I have been aware of a couple instances of failure of the audio amplifier IC in the Nouveau 75A. A finger test reveals that, sure enough, when running into the internal speaker at full volume, the IC runs hot. A couple solutions exist to help this part survive better:

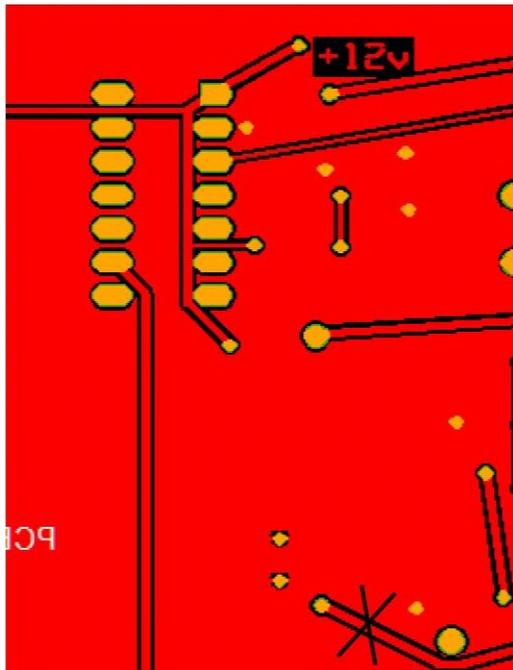
- a. Turn the board over to expose the bottom side of the PCB. On the left side of the board, under the 14 pin DIP, sever the trace per the first picture. Scrape back the solder mask on either side of the cut.

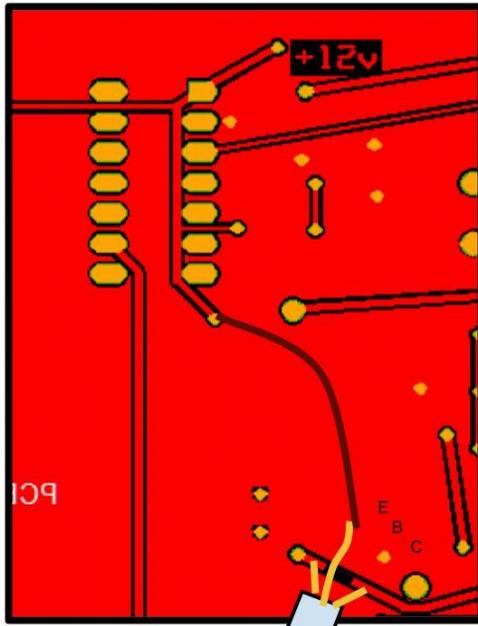
Scrape back the solder mask on either side of the cut.. Add a 2N3904 transistor, flat side down, per the attached picture. The left and right leads of the transistor are to be soldered down to bridge the cut trace. The middle lead is to be connected by a fine wire (like magnet wire) to the via below and slightly to the right of the 14 pin DIP IC. Place a small piece of insulating tape under the middle leg of the transistor to prevent it shorting out against the other leads.
